**TOWN OF MOUNTAIN VILLAGE  
REGULAR DESIGN REVIEW BOARD MEETING  
THURSDAY OCTOBER 4, 2018 10:00 AM  
2nd FLOOR CONFERENCE ROOM, MOUNTAIN VILLAGE TOWN HALL  
455 MOUNTAIN VILLAGE BLVD, MOUNTAIN VILLAGE, COLORADO  
AGENDA**

**TO:** Design Review Board  
**FROM:** Sam Starr, Planner  
**FOR:** Meeting of October 4, 2018  
**DATE:** September 27, 2018  
**RE:** Consideration of an Final Review application for a new single-family residence on Lot AR-49, 116 Adams Way

# LS 2 RESIDENCE

**LS2 RESIDENCE**  
LOT AR-49 116 ADAMS WAY  
TELLURIDE MOUNTAIN VILLAGE

MATERIAL CALCULATIONS

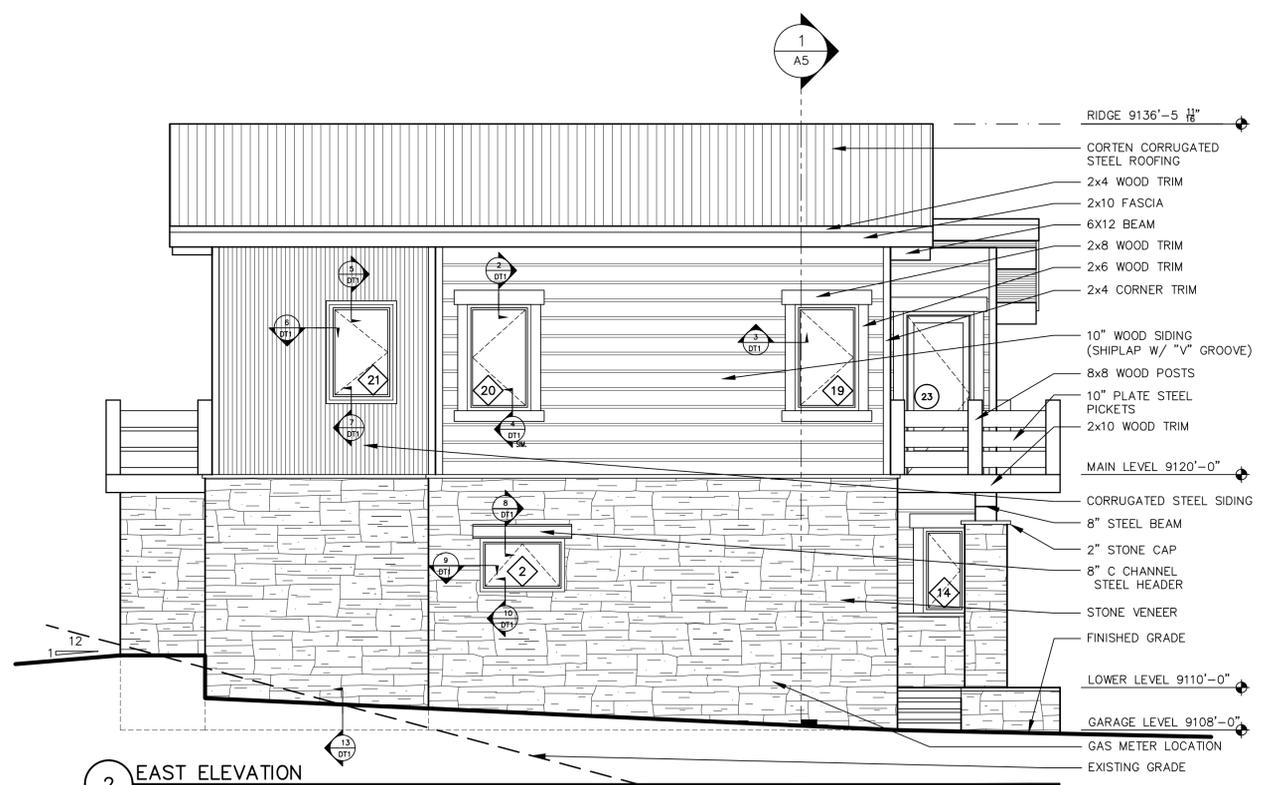
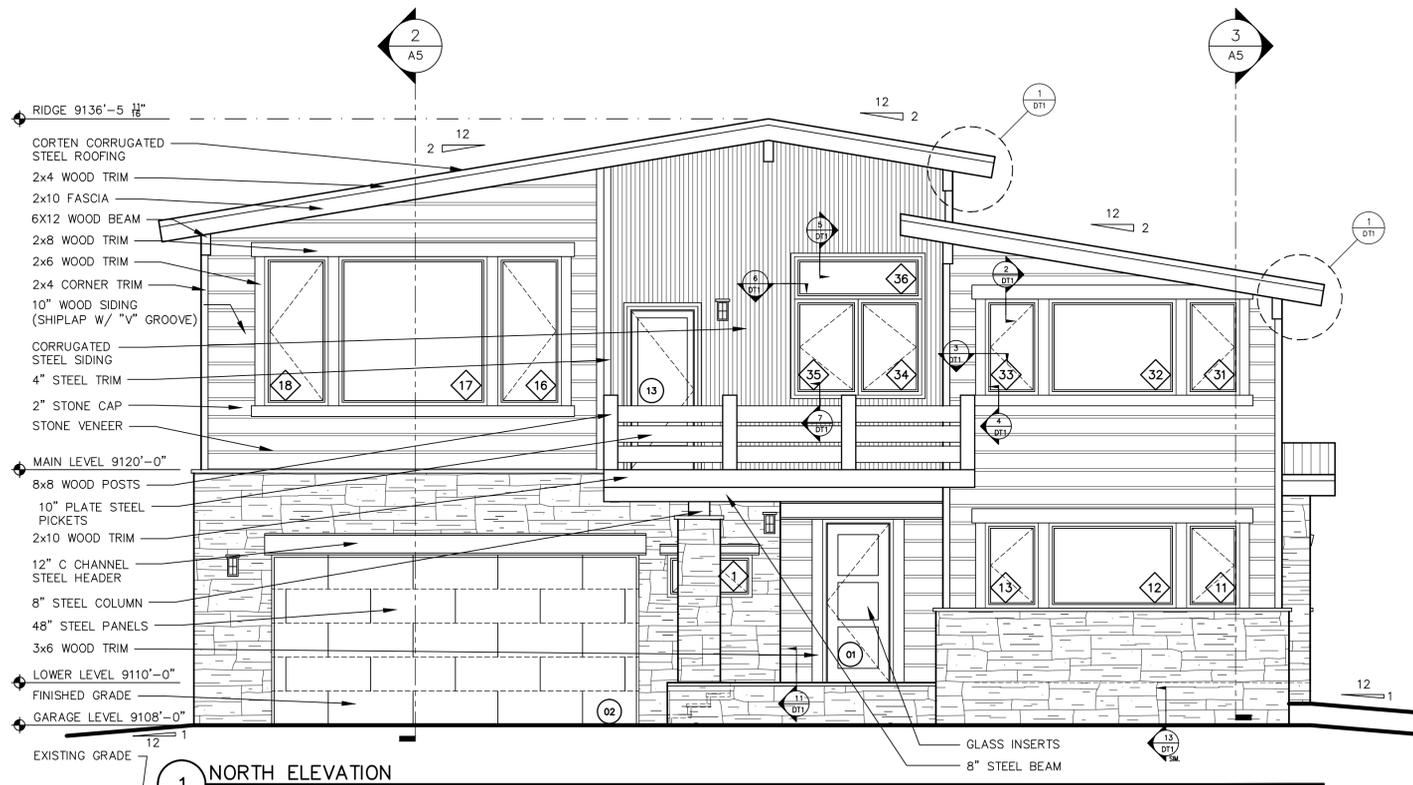
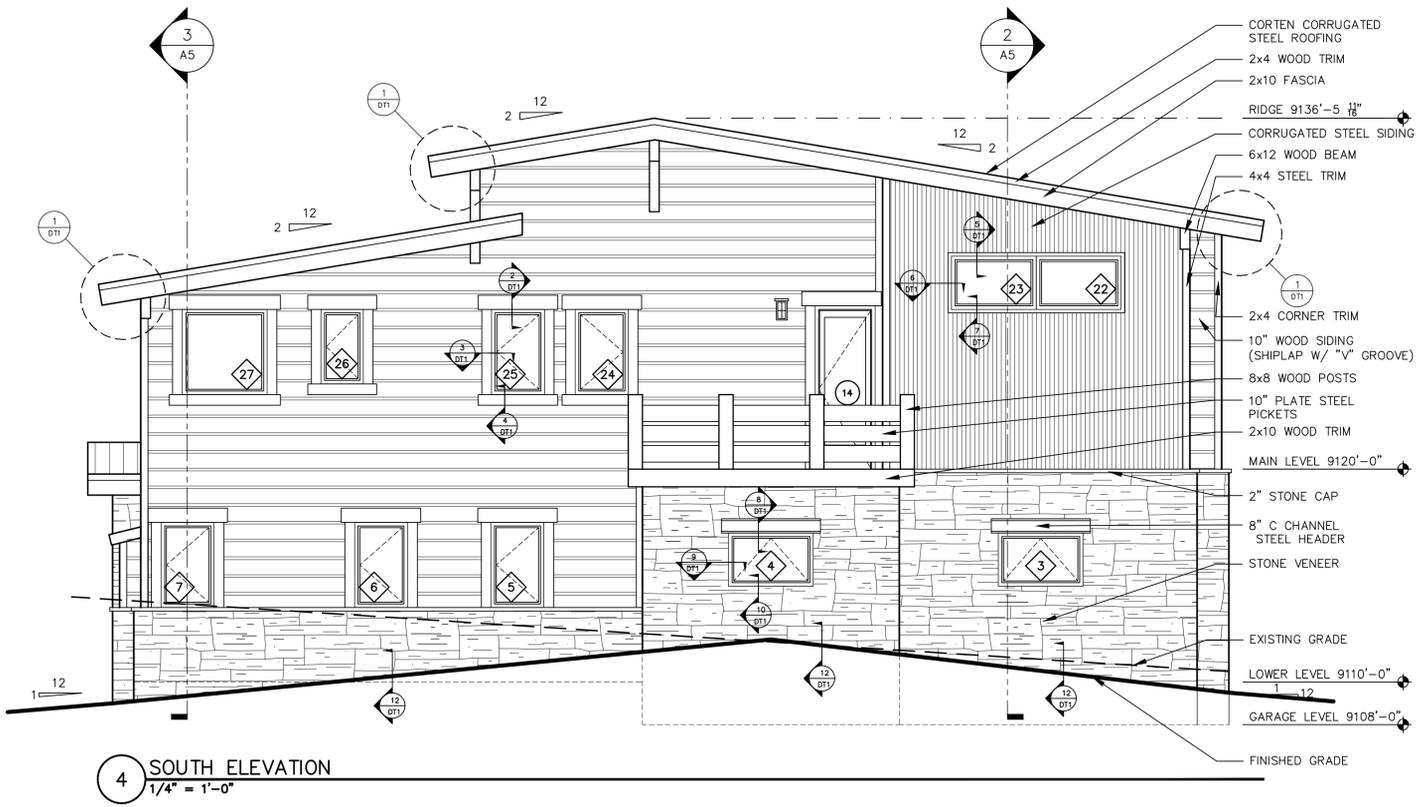
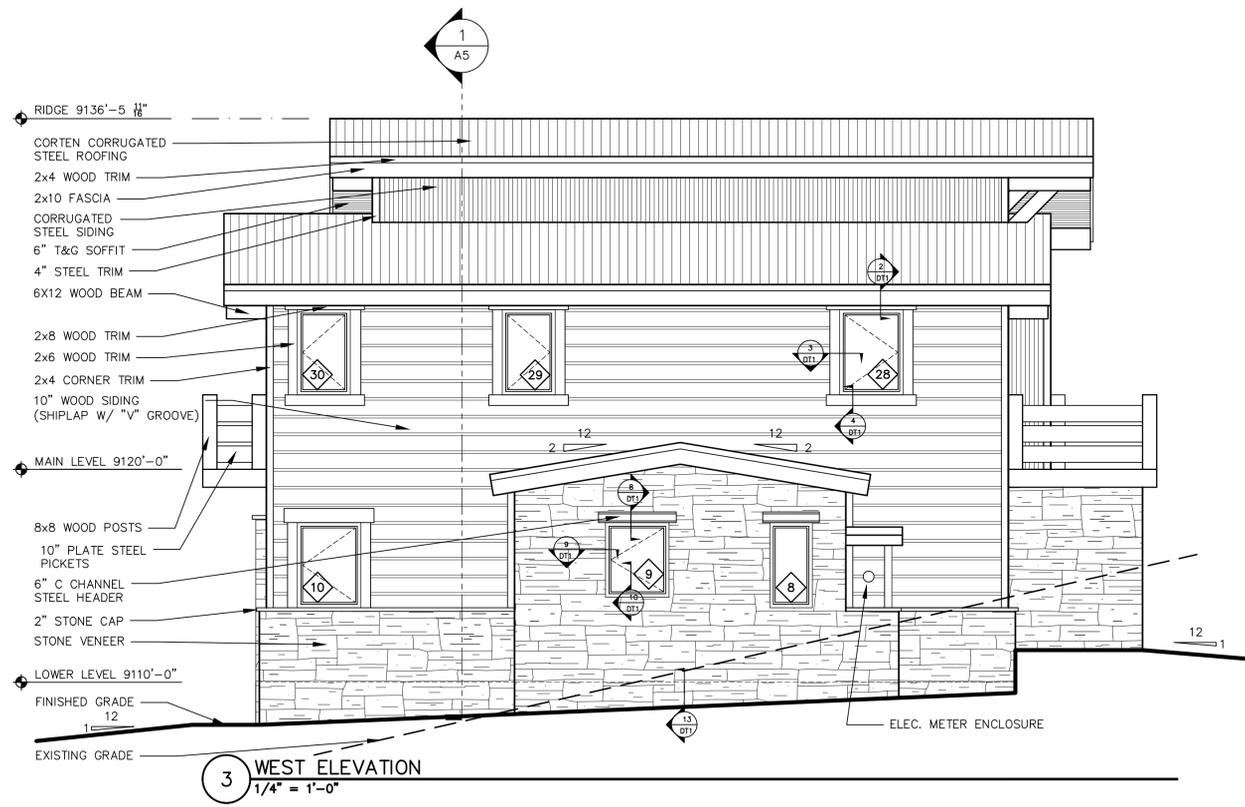
In response to a valid opinion pertaining to the arrangement of rock on the north and east elevations, we have rearranged the rock elevations to appear more visually pleasing while maintaining the 35% coverage.

**LOT AR49**  
**Exterior Lighting Plan**

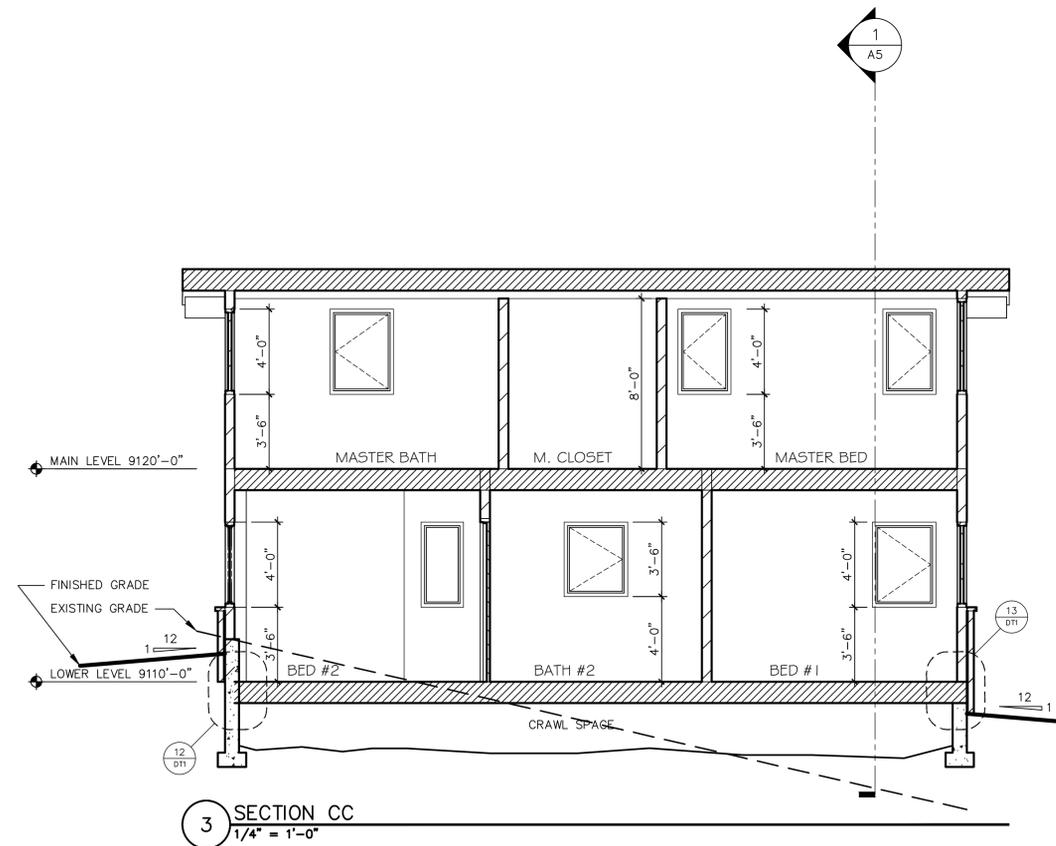
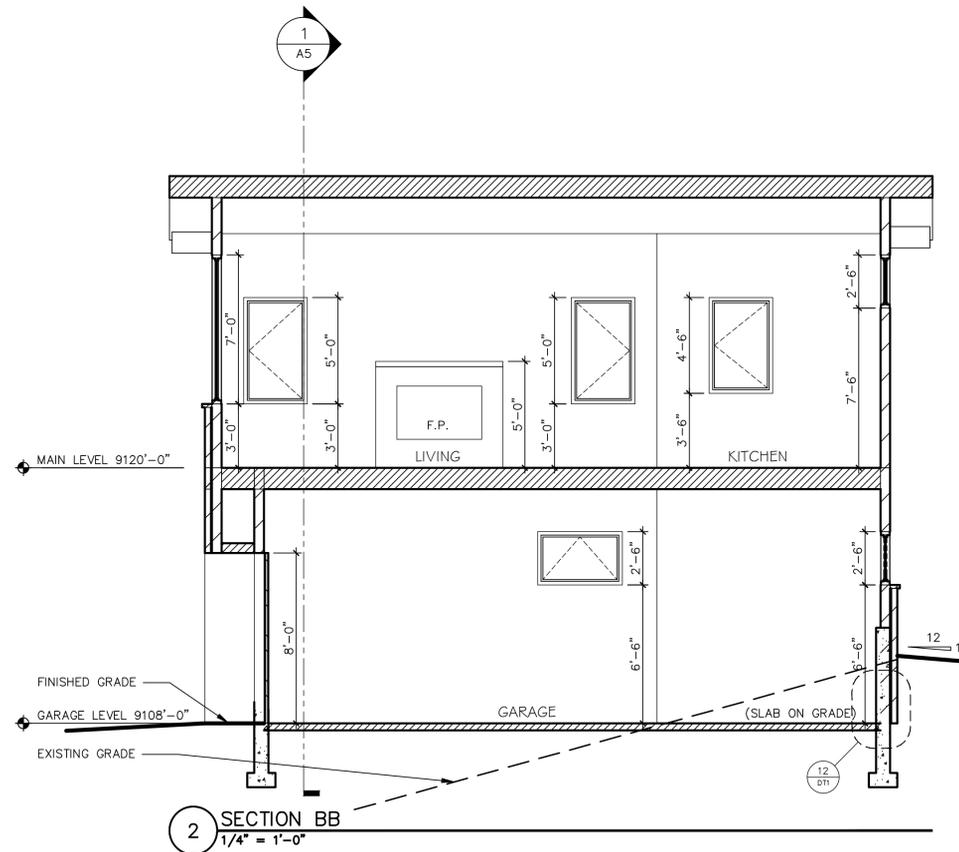
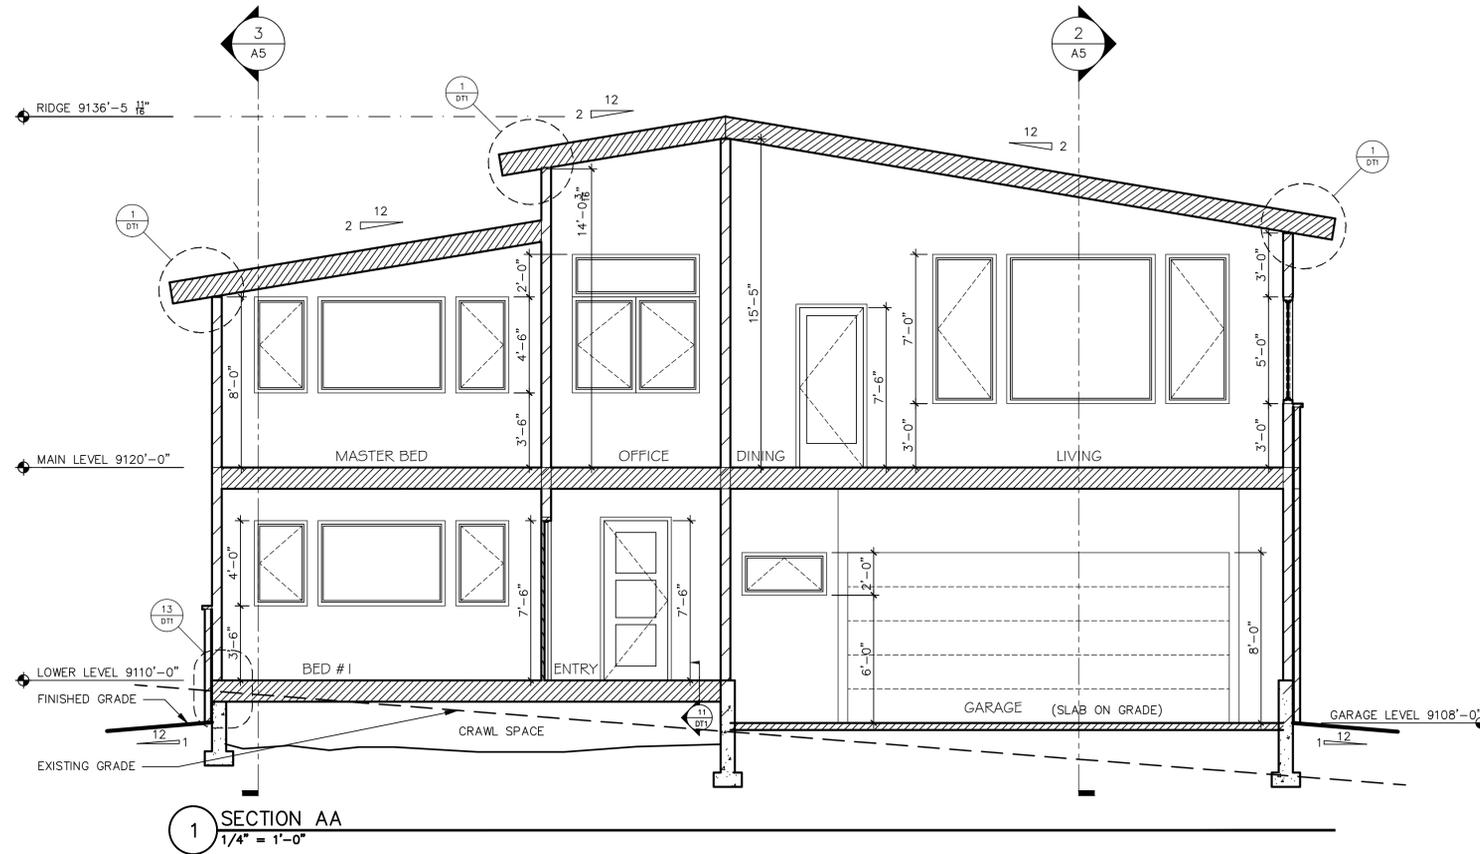
In response to the Board's concerns, we have changed the exterior light fixture to an LED compliant fixture.

**ADDRESS MONUMENT**

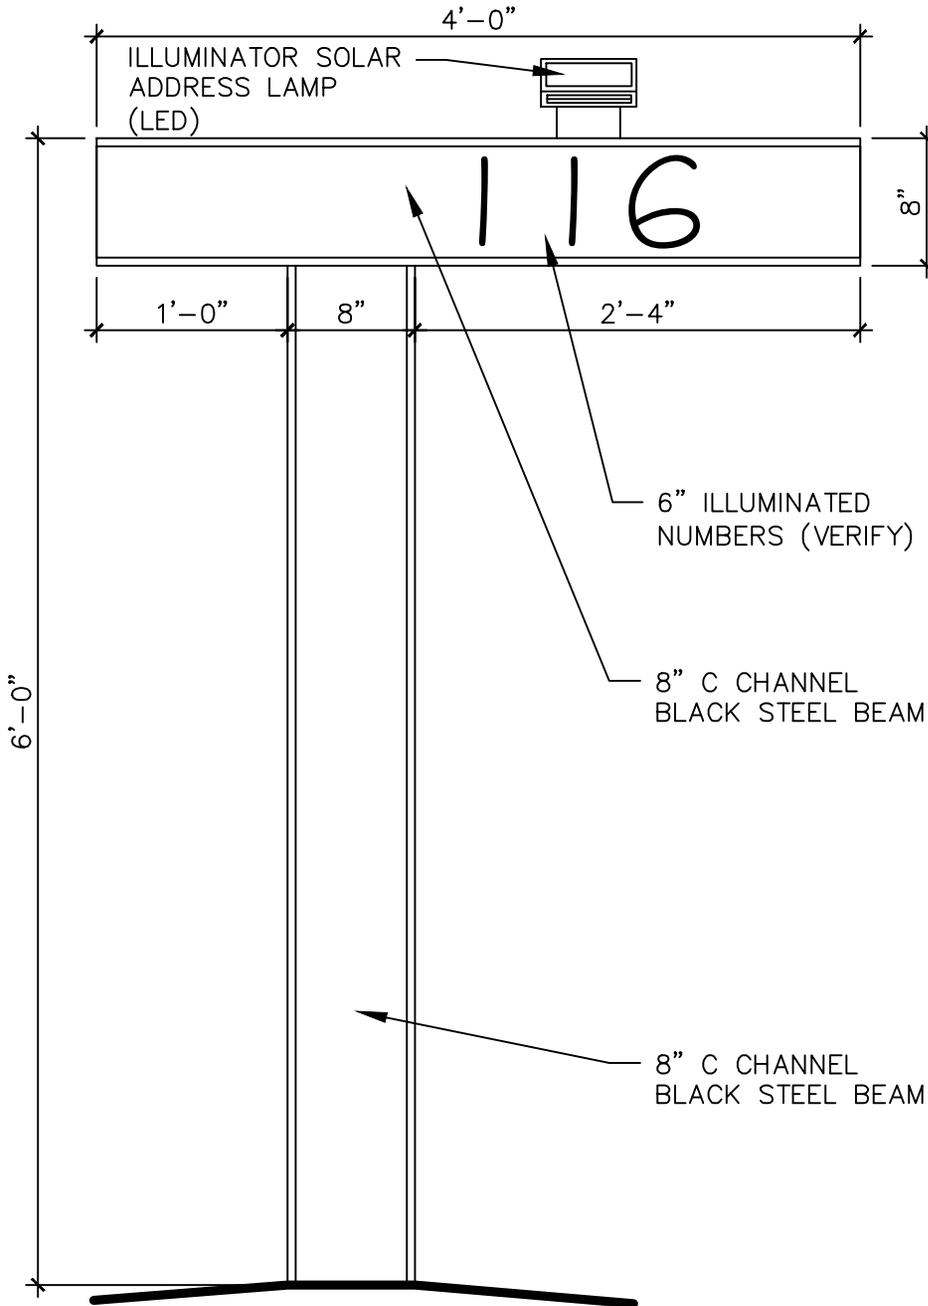
- 4) *Applicant will provide an updated address identification sign demonstrating the presence of a downlit concealed, LED light.*
- 5) *Exterior lighting plan be revised as discussed during DRB deliberation, which includes:*
